This drawing and the design it covers are the property of BECHTEL. They are loaned and on the borrower's express agreement that they will not be reproduced, copied, loaned, exhibited, nor used except in the limited way and private use permitted by the lender to the borrower.

UNCONTROLLED DOCUMENT FOR REFERENCE ONLY

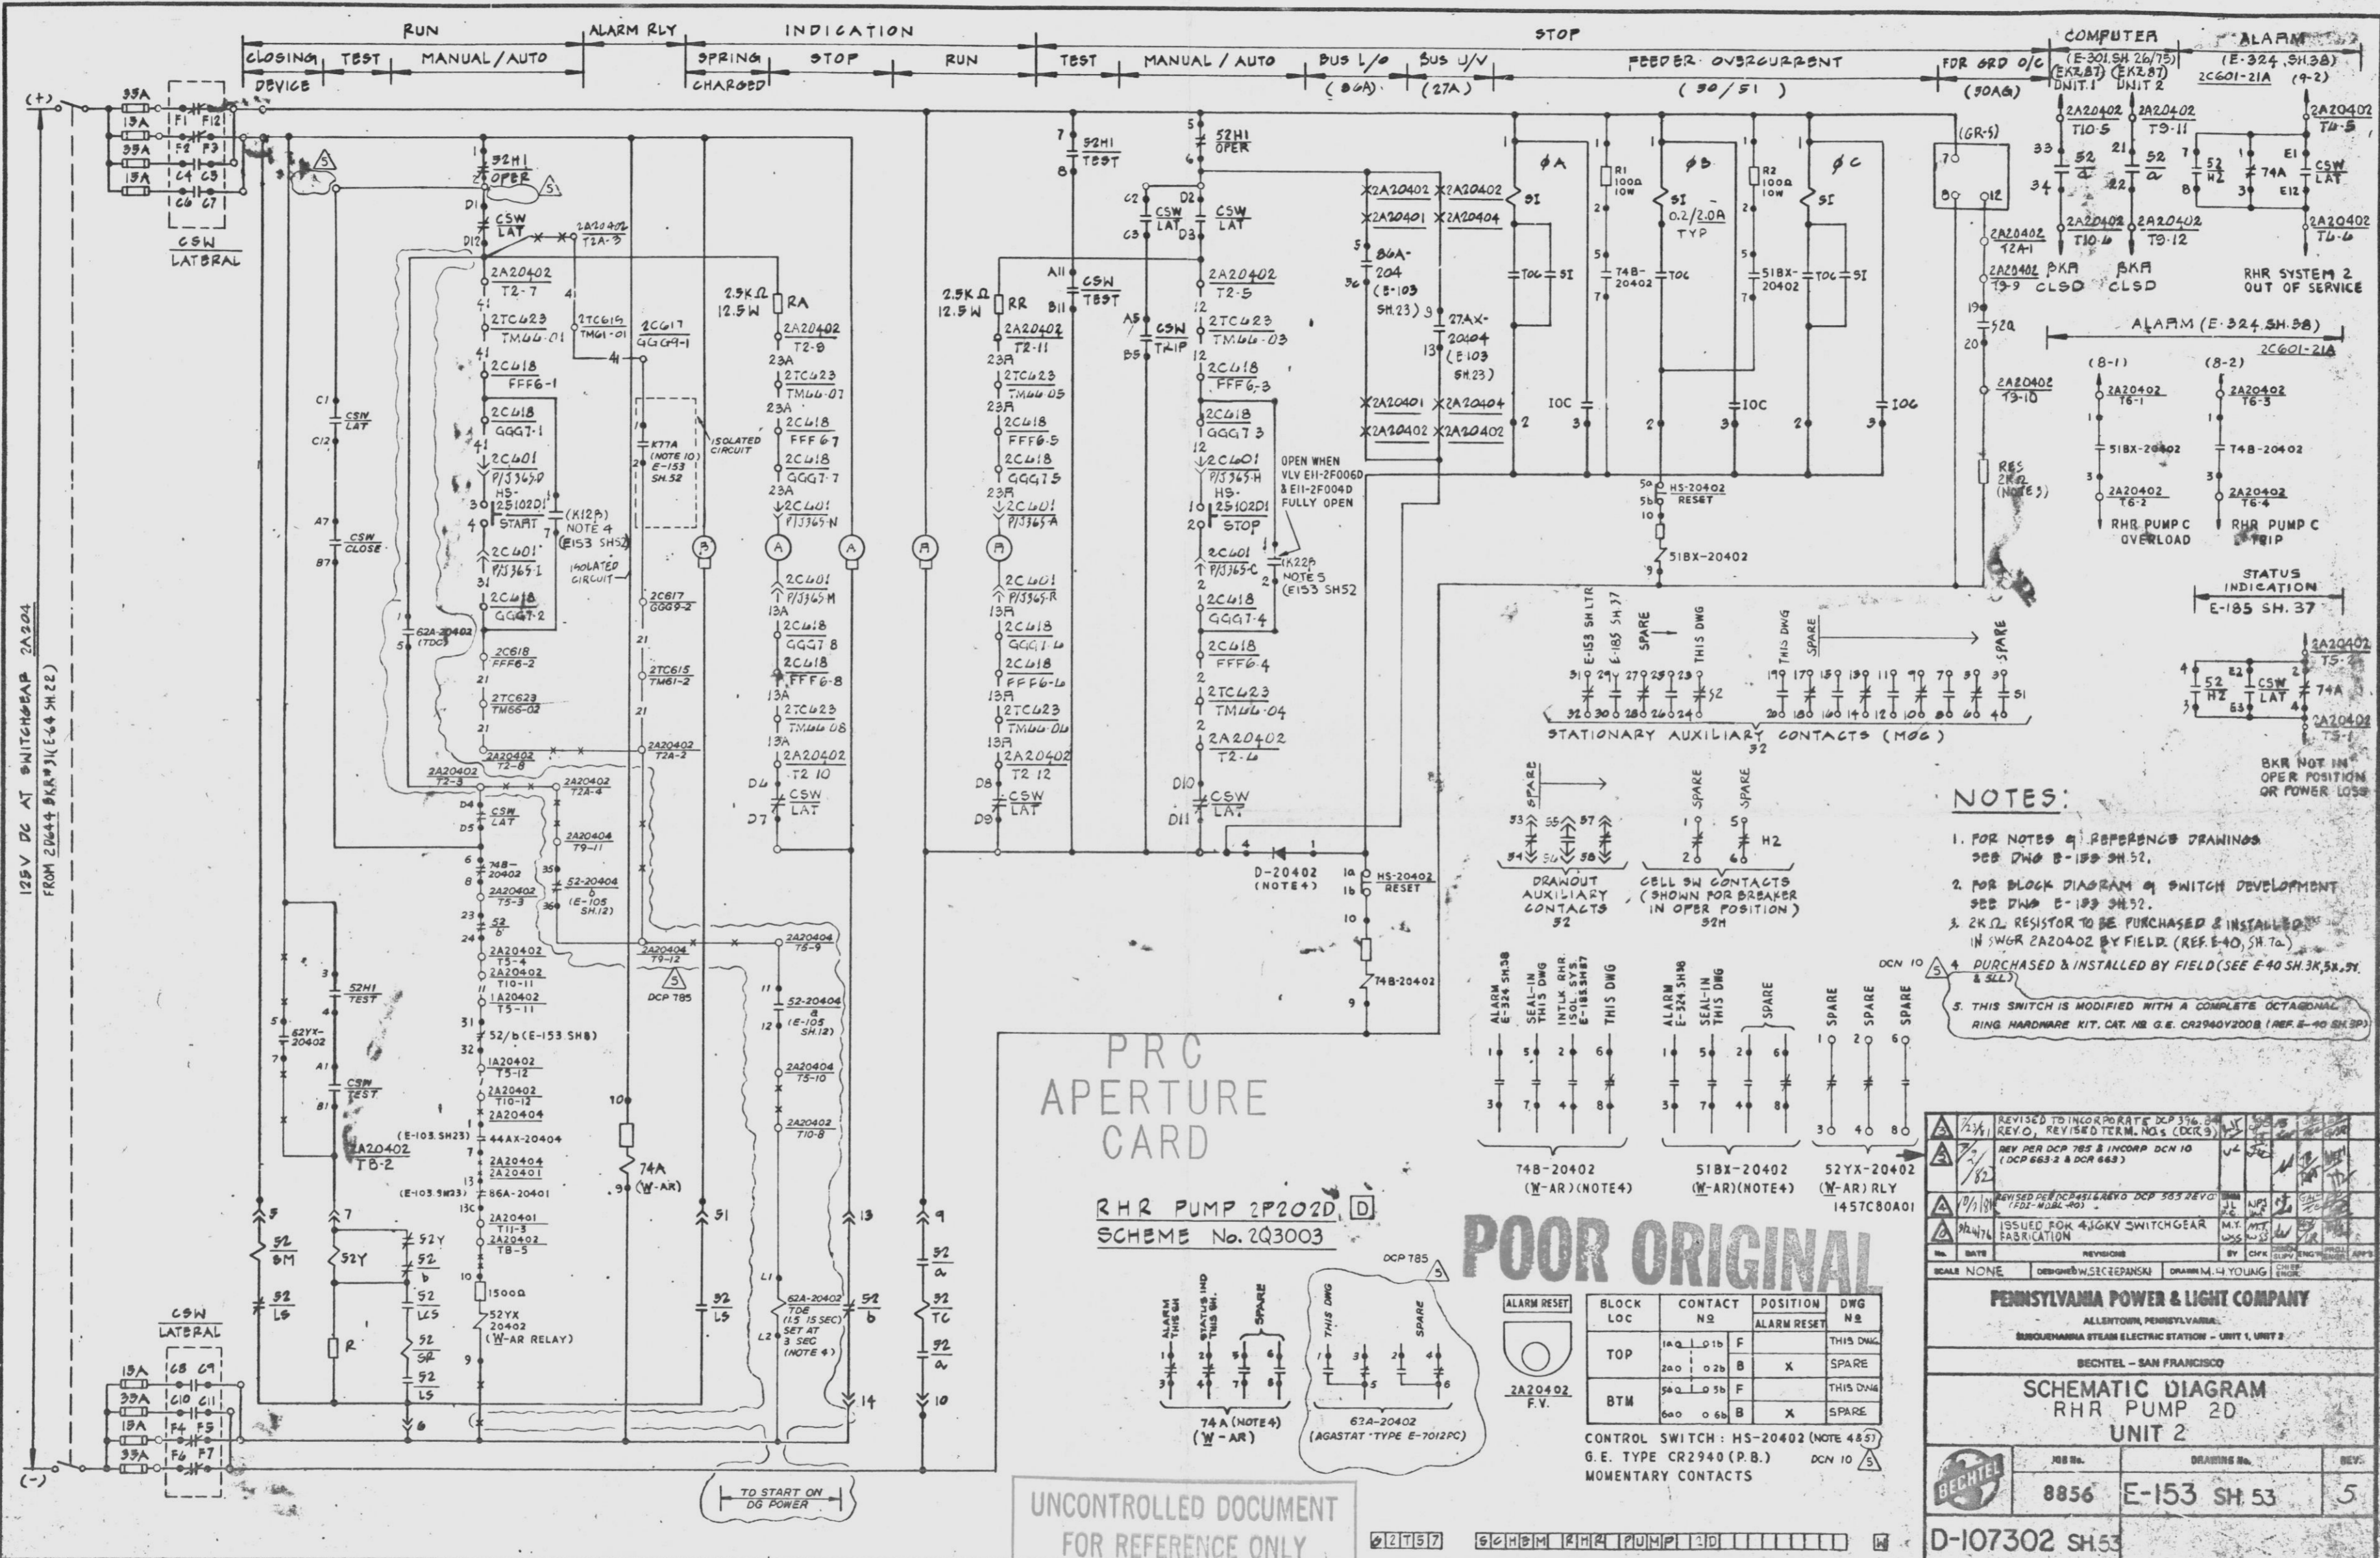
NO.	DATE	REVISIONS	BY	CHK	APP'G	
1		REVISED TO INCORPORATE DCP 376, 377, 378, 379, 380, 381, 382, 383, 384, 385, 386, 387, 388, 389, 390, 391, 392, 393, 394, 395, 396, 397, 398, 399, 400, 401, 402, 403, 404, 405, 406, 407, 408, 409, 410, 411, 412, 413, 414, 415, 416, 417, 418, 419, 420, 421, 422, 423, 424, 425, 426, 427, 428, 429, 430, 431, 432, 433, 434, 435, 436, 437, 438, 439, 440, 441, 442, 443, 444, 445, 446, 447, 448, 449, 450, 451, 452, 453, 454, 455, 456, 457, 458, 459, 460, 461, 462, 463, 464, 465, 466, 467, 468, 469, 470, 471, 472, 473, 474, 475, 476, 477, 478, 479, 480, 481, 482, 483, 484, 485, 486, 487, 488, 489, 490, 491, 492, 493, 494, 495, 496, 497, 498, 499, 500, 501, 502, 503, 504, 505, 506, 507, 508, 509, 510, 511, 512, 513, 514, 515, 516, 517, 518, 519, 520, 521, 522, 523, 524, 525, 526, 527, 528, 529, 530, 531, 532, 533, 534, 535, 536, 537, 538, 539, 540, 541, 542, 543, 544, 545, 546, 547, 548, 549, 550, 551, 552, 553, 554, 555, 556, 557, 558, 559, 560, 561, 562, 563, 564, 565, 566, 567, 568, 569, 570, 571, 572, 573, 574, 575, 576, 577, 578, 579, 580, 581, 582, 583, 584, 585, 586, 587, 588, 589, 590, 591, 592, 593, 594, 595, 596, 597, 598, 599, 600, 601, 602, 603, 604, 605, 606, 607, 608, 609, 610, 611, 612, 613, 614, 615, 616, 617, 618, 619, 620, 621, 622, 623, 624, 625, 626, 627, 628, 629, 630, 631, 632, 633, 634, 635, 636, 637, 638, 639, 640, 641, 642, 643, 644, 645, 646, 647, 648, 649, 650, 651, 652, 653, 654, 655, 656, 657, 658, 659, 660, 661, 662, 663, 664, 665, 666, 667, 668, 669, 670, 671, 672, 673, 674, 675, 676, 677, 678, 679, 680, 681, 682, 683, 684, 685, 686, 687, 688, 689, 690, 691, 692, 693, 694, 695, 696, 697, 698, 699, 700, 701, 702, 703, 704, 705, 706, 707, 708, 709, 710, 711, 712, 713, 714, 715, 716, 717, 718, 719, 720, 721, 722, 723, 724, 725, 726, 727, 728, 729, 730, 731, 732, 733, 734, 735, 736, 737, 738, 739, 740, 741, 742, 743, 744, 745, 746, 747, 748, 749, 750, 751, 752, 753, 754, 755, 756, 757, 758, 759, 760, 761, 762, 763, 764, 765, 766, 767, 768, 769, 770, 771, 772, 773, 774, 775, 776, 777, 778, 779, 780, 781, 782, 783, 784, 785, 786, 787, 788, 789, 790, 791, 792, 793, 794, 795, 796, 797, 798, 799, 800, 801, 802, 803, 804, 805, 806, 807, 808, 809, 810, 811, 812, 813, 814, 815, 816, 817, 818, 819, 820, 821, 822, 823, 824, 825, 826, 827, 828, 829, 830, 831, 832, 833, 834, 835, 836, 837, 838, 839, 840, 841, 842, 843, 844, 845, 846, 847, 848, 849, 850, 851, 852, 853, 854, 855, 856, 857, 858, 859, 860, 861, 862, 863, 864, 865, 866, 867, 868, 869, 870, 871, 872, 873, 874, 875, 876, 877, 878, 879, 880, 881, 882, 883, 884, 885, 886, 887, 888, 889, 890, 891, 892, 893, 894, 895, 896, 897, 898, 899, 900, 901, 902, 903, 904, 905, 906, 907, 908, 909, 910, 911, 912, 913, 914, 915, 916, 917, 918, 919, 920, 921, 922, 923, 924, 925, 926, 927, 928, 929, 930, 931, 932, 933, 934, 935, 936, 937, 938, 939, 940, 941, 942, 943, 944, 945, 946, 947, 948, 949, 950, 951, 952, 953, 954, 955, 956, 957, 958, 959, 960, 961, 962, 963, 964, 965, 966, 967, 968, 969, 970, 971, 972, 973, 974, 975, 976, 977, 978, 979, 980, 981, 982, 983, 984, 985, 986, 987, 988, 989, 990, 991, 992, 993, 994, 995, 996, 997, 998, 999, 1000
